# Authorized Field Change

**AFC G-01905**

**Subject File:** Front End Sheet Metal

**Subject:** Replacement Headlamp Assemblies for 4300 and 4400 Models Built Between October 24, 2000 and February 7, 2001

Figure 1 Headlamp Connector Seal

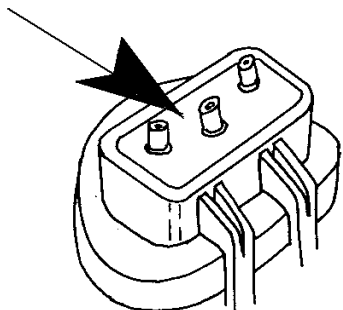
When installing the bulb connector to the headlamp assembly, the blades of the bulb terminals may have poor electrical contact with the harness connector resulting in heat build up and distortion of the connector body. Proper headlamp operation may be noted, however, progressive damage may occur with subsequent loss of headlamp illumination.

- B. If the harness connector body is colored black with a dark blue seal (see arrow in Figure 1), the headlamp assembly must be replaced. Proceed to the Service Procedure.
